Yarnton, Cherwell

Application Comments Response Note

162751A/N03

Planning Application 21/03522/OUT

Figure 1. showing intervisibility required (black lines) between the medical centre access and Rutten Lane

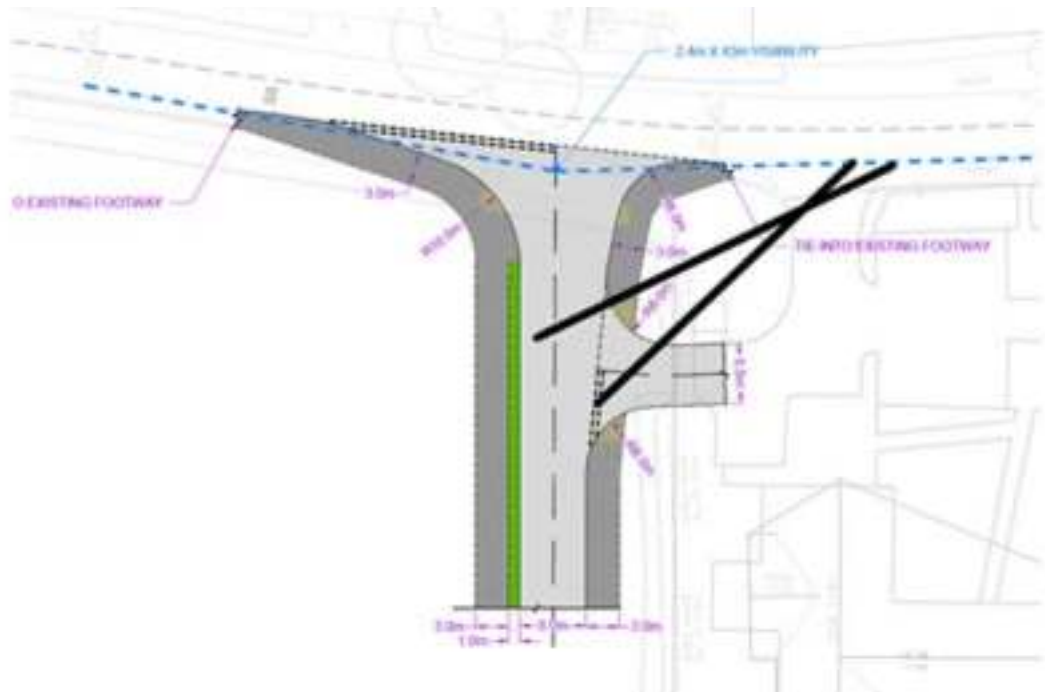
Lane is achieved, as per the black lines in Figure 1 below. This will need to be demonstrated.

A gateway / traffic calming feature will be required on Rutten Lane to the north of the vehicle access to ensure that speeds of vehicles exiting the A44 are lowered appropriately on the approach to the site access, which on the edge of the current extent of Yarnton village. An amended highway works plan should be provided demonstrating the inclusion of such a feature.

13. It is equally considered that the information provided on the **Drawing 162751A/PD02 Rev A** provided at **Appendix C** addresses the comments made by YPC. The inclusion of a traffic calming/gateway feature will help reduce the occurrences of vehicles disobeying the current posted speed limit, which has been cited by YPC as a concern. **Drawing 162751A/PD01 Rev B** also confirms that the location of the build out is such that suitable forward visibility is achieved in both directions.

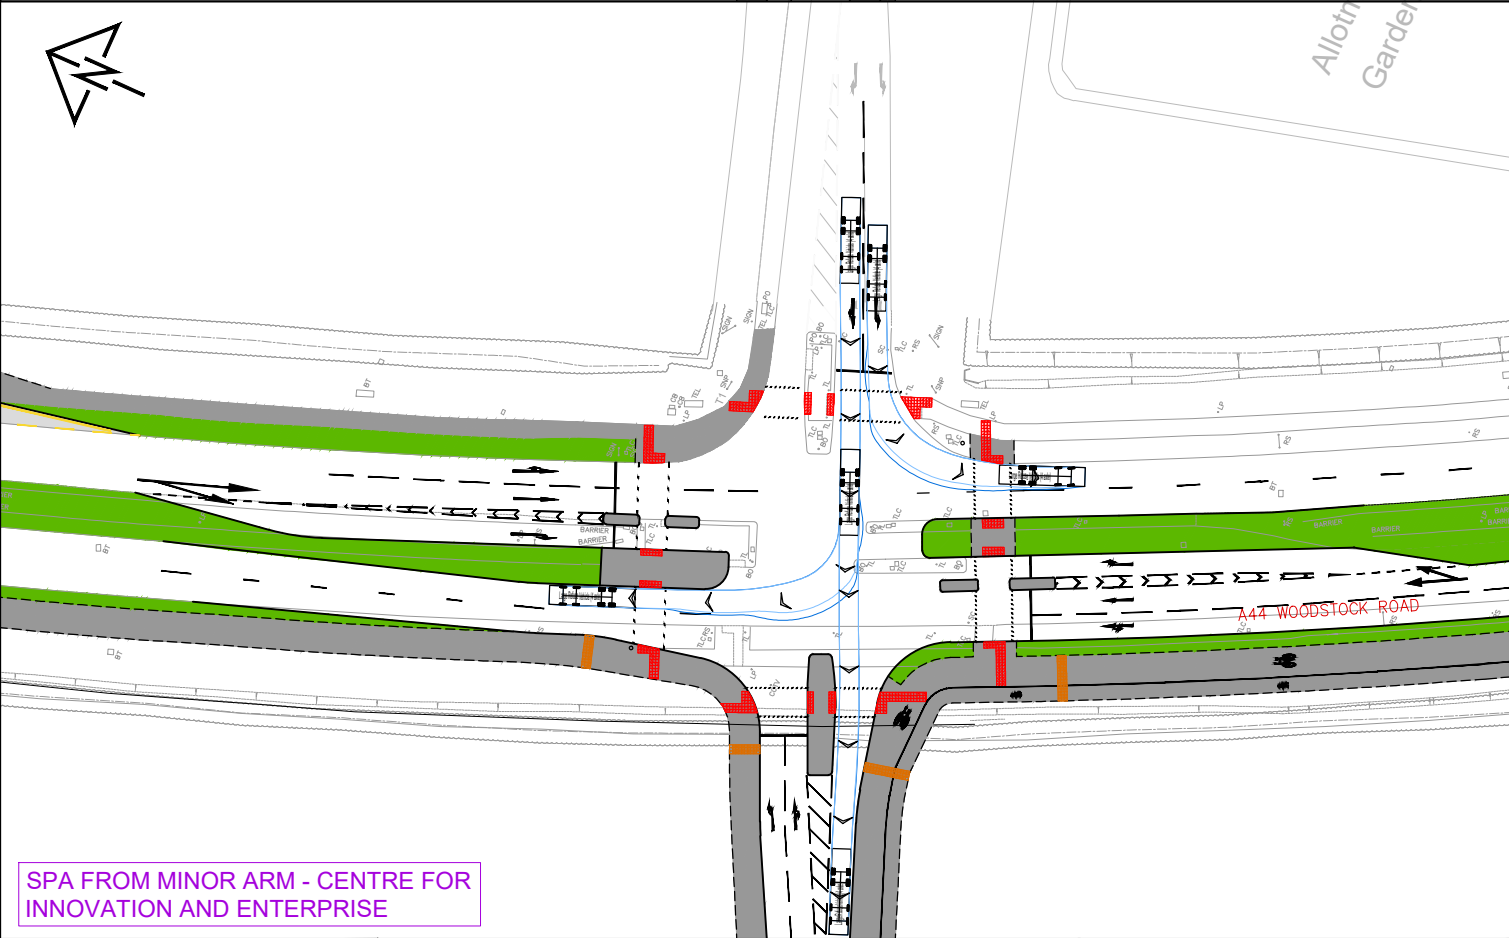
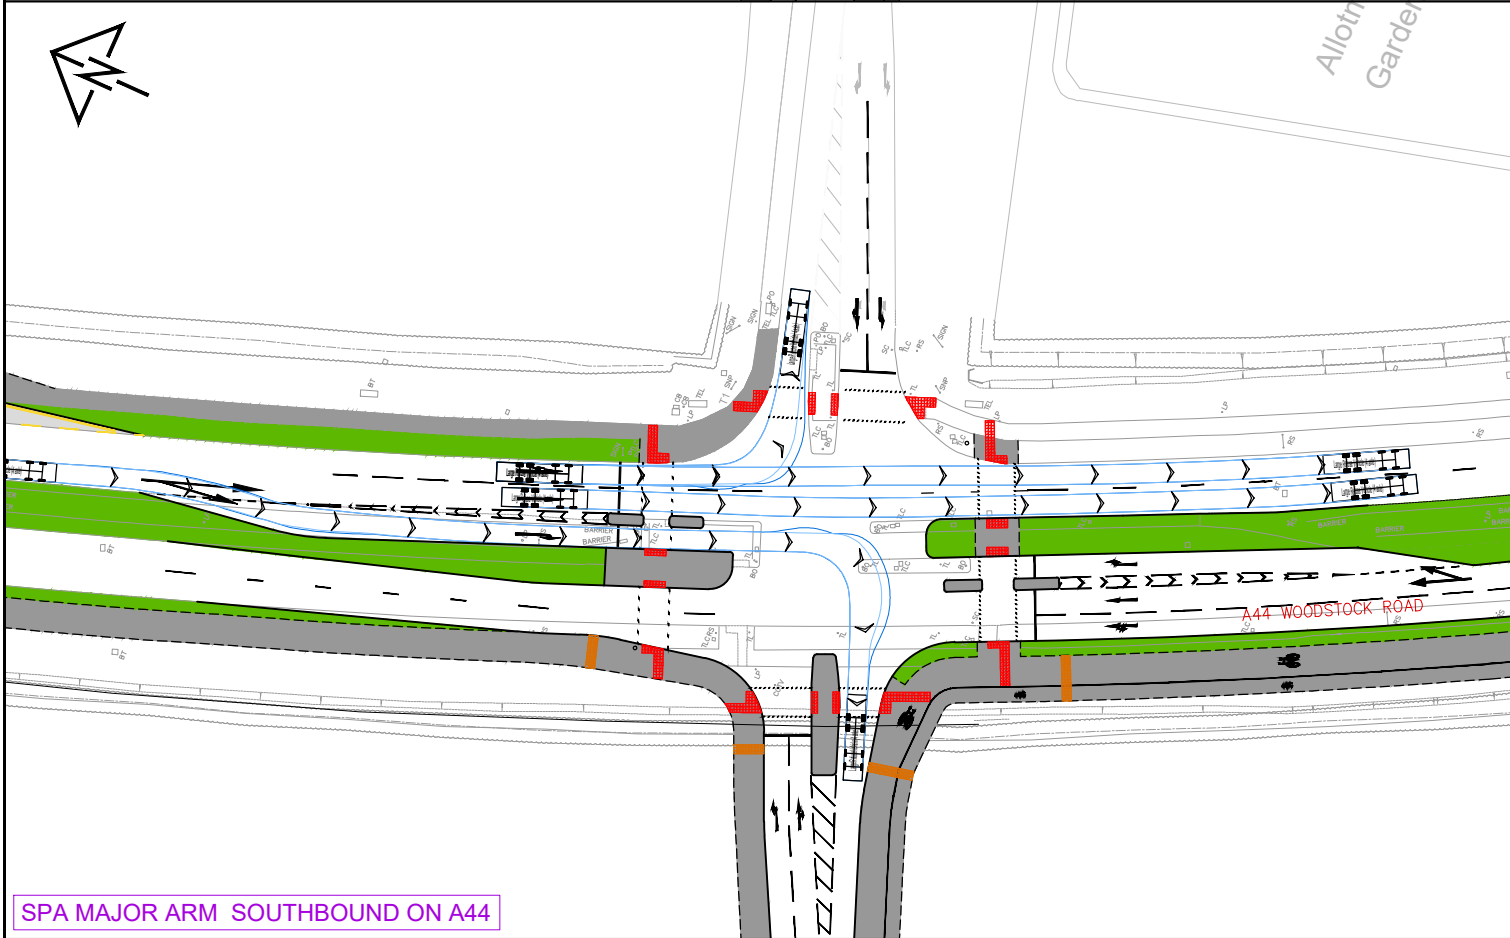
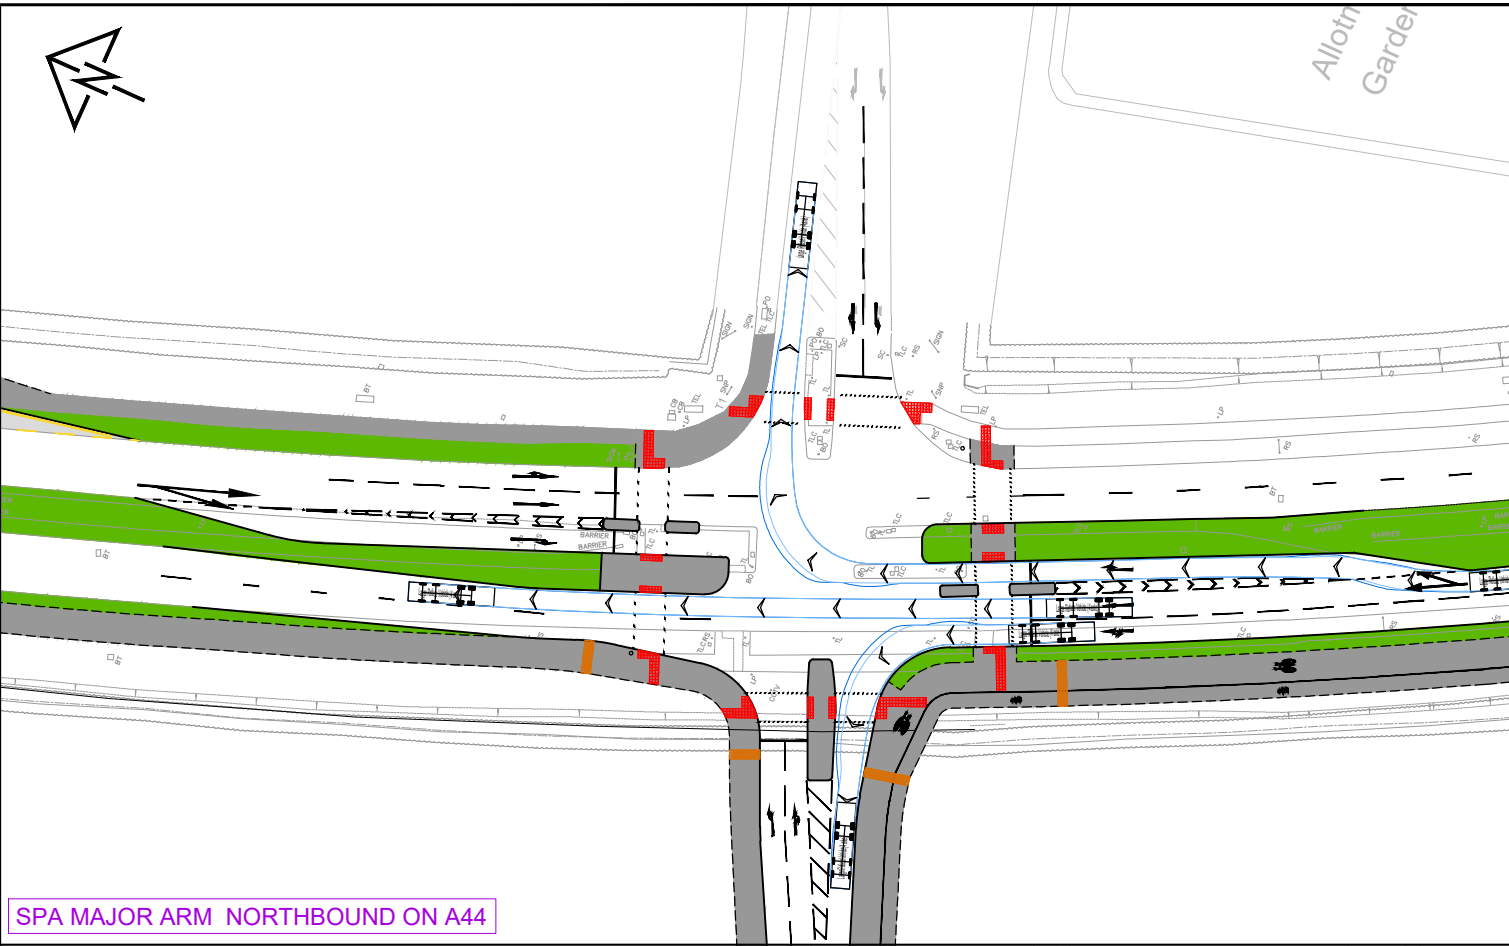
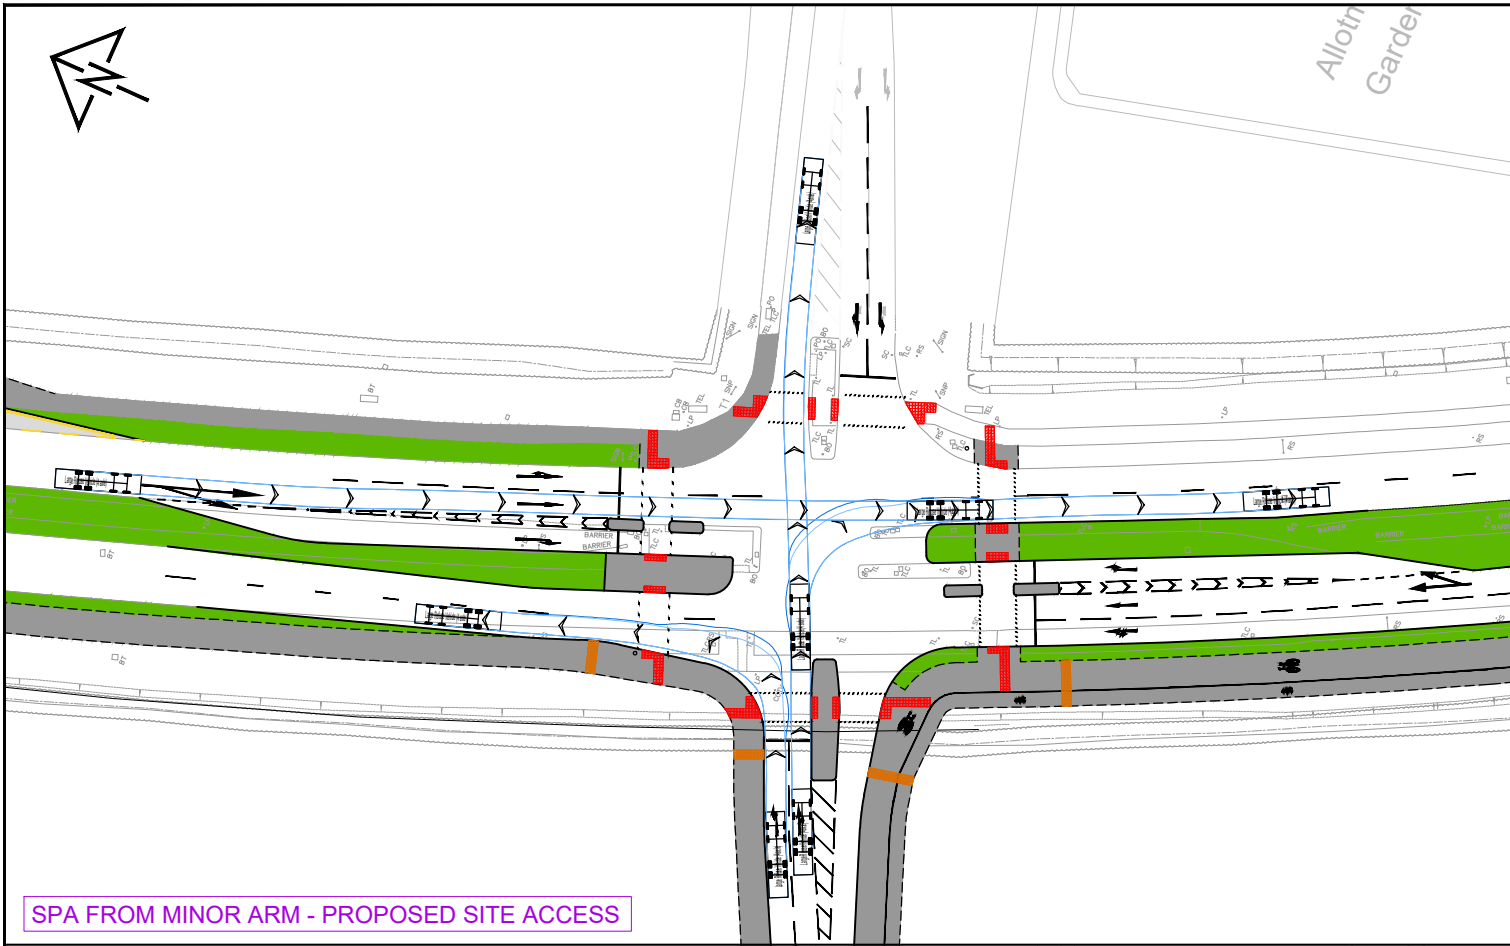
11. Further to comments received from OCC and YPC seven additional drawings have been prepared and are provided at **Appendix C**. These show:
 - Drawing 162751/B01 Rev E – crossing points incorporated into the A44/ Begbroke Science Park access are direct and not staggered, as requested by OCC;

26. As with the works shown on (updated) **Drawing 162751/B01 Rev E**, the Applicant intends to deliver the extended section of shared pedestrian/cycleway via a Section 278 Agreement. For clarity, and thorough reference to the current preferred designs shown on the Skanska drawings provided by OCC, which are consistent with the requirements of LTN 1/20, the following figures show the areas of works that will be delivered by the Applicant. The areas shown in magenta are those referenced in the TA and ES, with those shown in green being the extended section now being proposed.
